Our Ref – U11840
Your Ref – MP05-0016

REQUEST TO MODIFY A DEVELOPMENT APPROVAL UNDER SECTION 75W OF THE EP&A ACT – MAJOR PROJECT APPLICATION MP05_0016 DOLPHIN POINT FOR HAZCORP PTY LTD – MOD 4

Figure 1 - SIX portal Lot layout

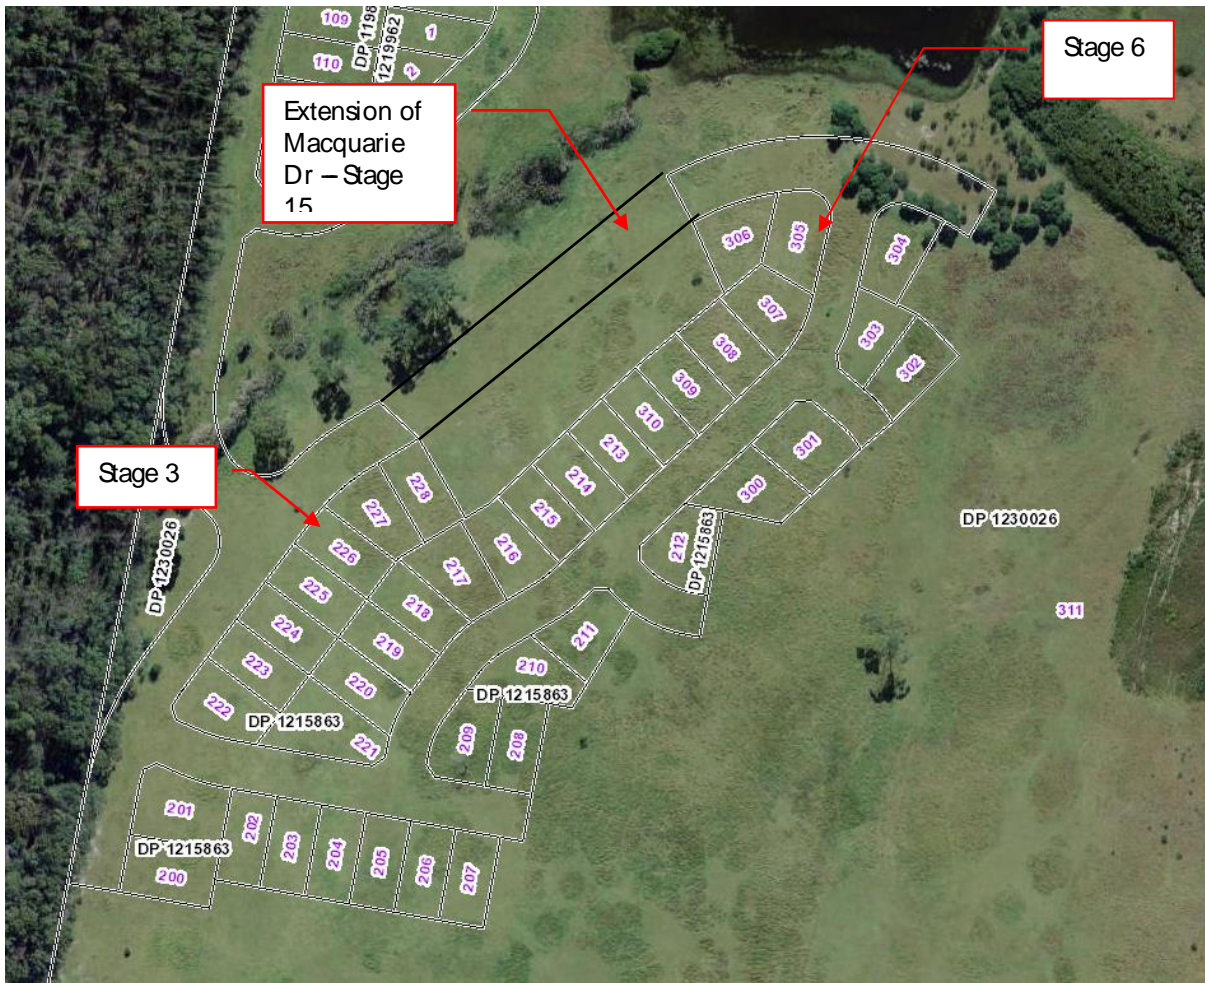
The extension of the road between Stages 3 and 6 allows a much easier travel route for residents in Lot 6 to travel from Wuru Drive. Currently the lots in Stage 6 need to travel road 3 (Macquarie Drive) into road 7 (Como Ave) and into road 4 (Superior Ave) to get to their lots.

The distance currently travelled by those owning Lots 305 for example is approximately 450m where it is only 140m in a direct line through Stage 15. Council are in favour of the construction of this section of road as it will spread the wear of the construction traffic more evenly.

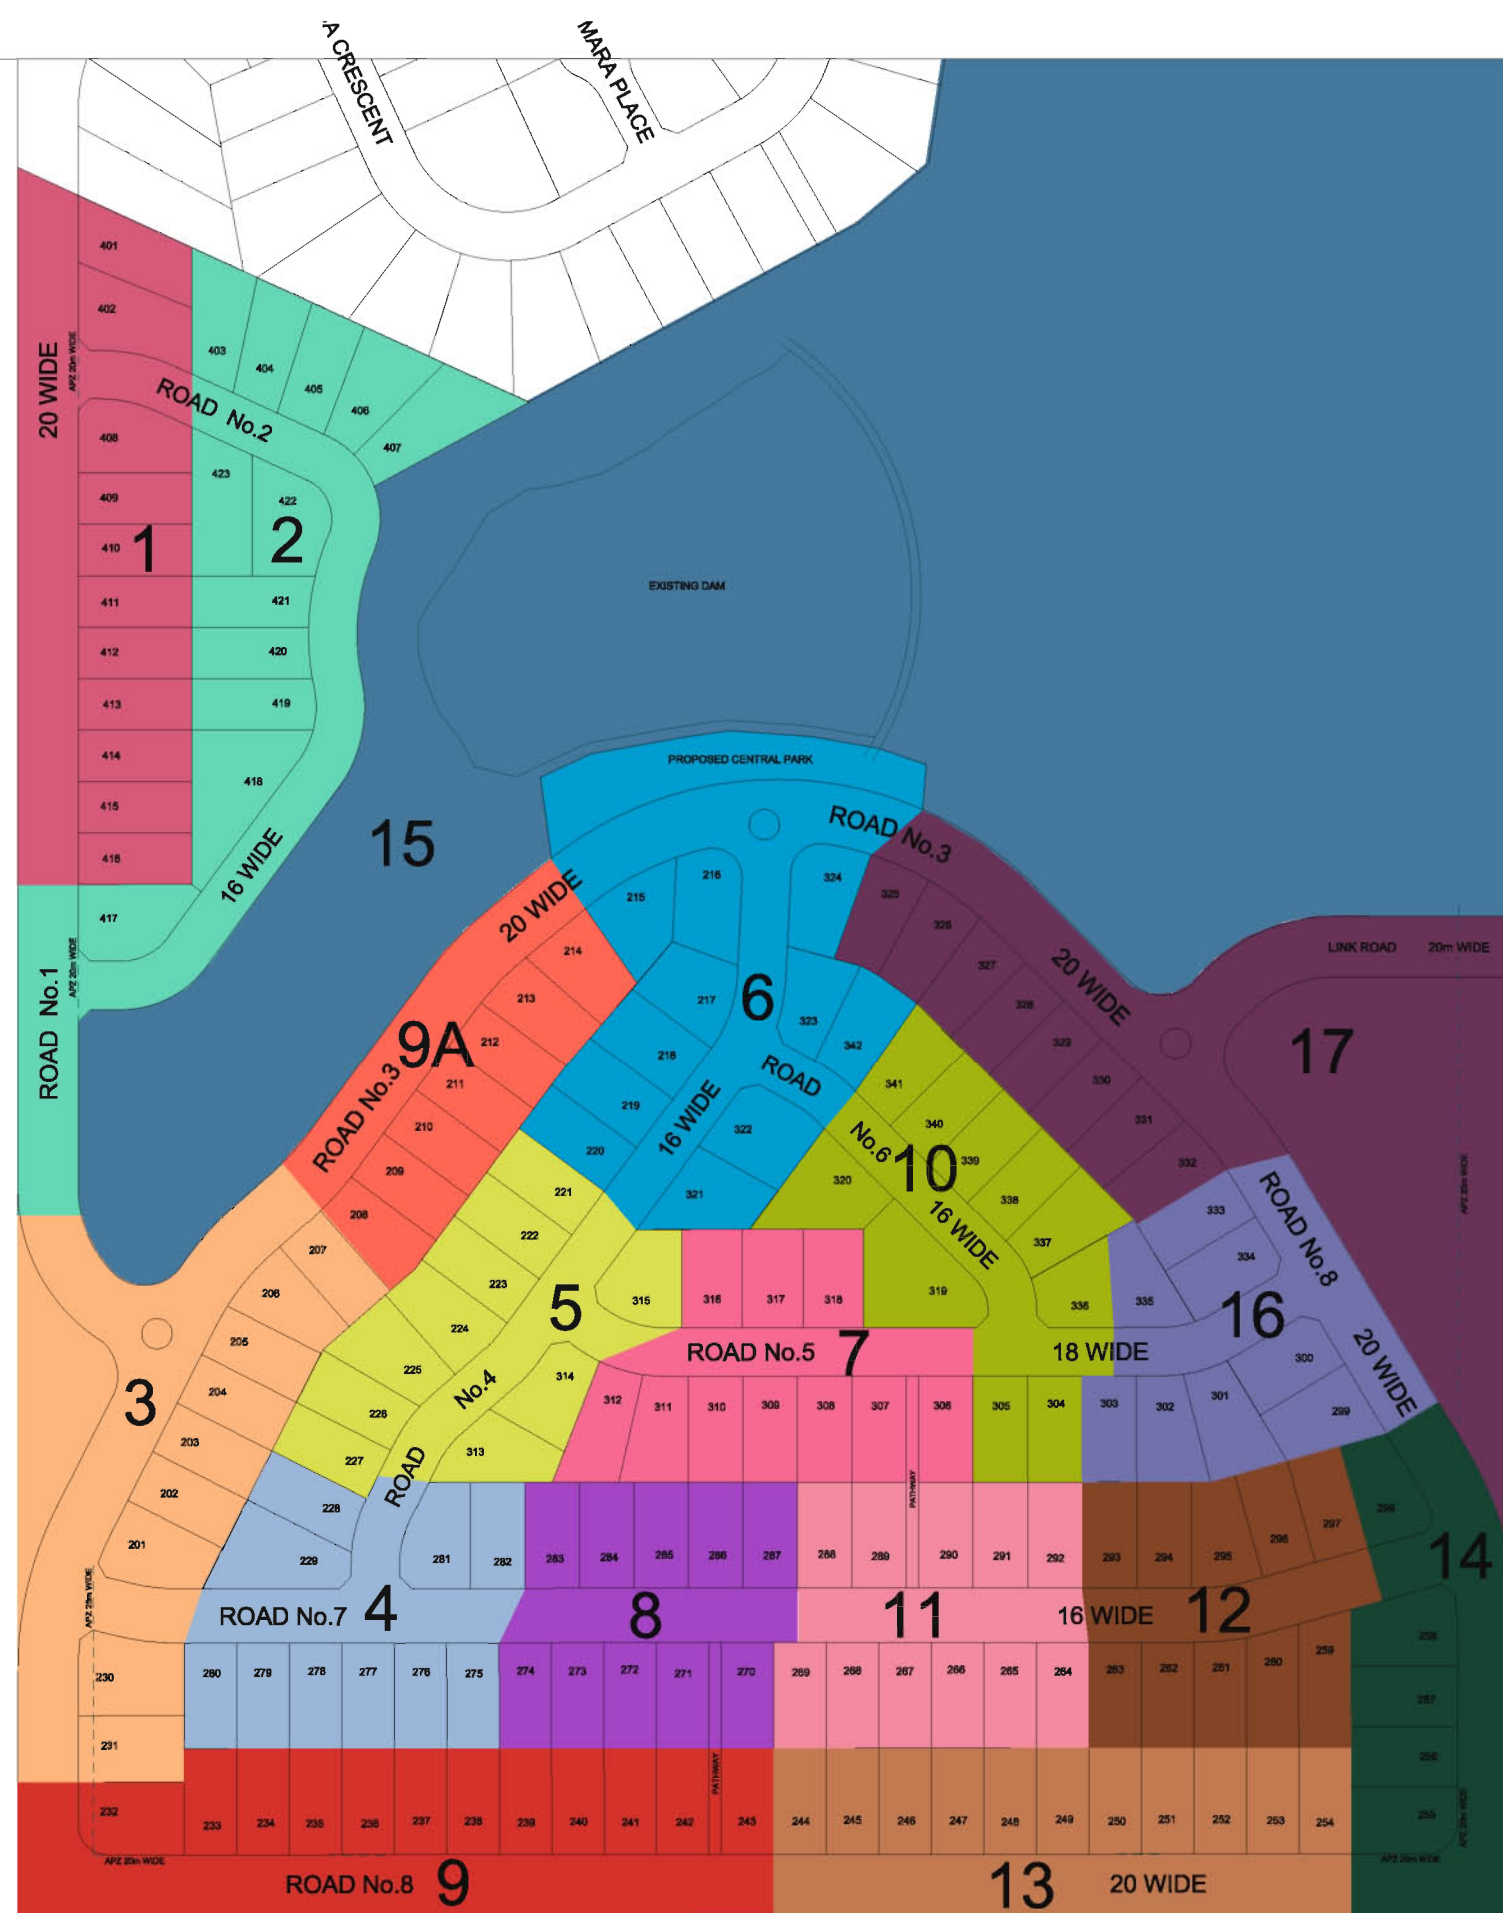
“Modify the staging of the subdivision to include the residential component of Stage 15 in a new substage being Stage 9A to provide better access to the lots in Stages 3-6. The remainder of Stage 15 will remain as is”

Justification: The primary reason for this amendment is to bring lots 208 – 215 into Stage 9A so that the road connection can be completed and Macquarie Drive constructed as part of stage 9A. This is a logical and orderly expansion of the development and how it should progress. The continuation of the road allows ready access for bushfire and emergency service vehicles to the existing lots in the subdivision constructed under Stage 6. This will not have an adverse impact upon traffic management in the subdivision as ultimately these lots would have been released before the subdivision was completed. The remainder of stage 15 will remain as currently approved.

The subdivision development shall be carried out generally in accordance with the approved staging plans, in numerical order, referred to in the Conceptual Staging Plan prepared by Rygate and West, Drawing No U11840M Sheet 4 of 4, Revision ~~D~~ **13 November 2013 G-24 August 2017 H 11 October 2017**.
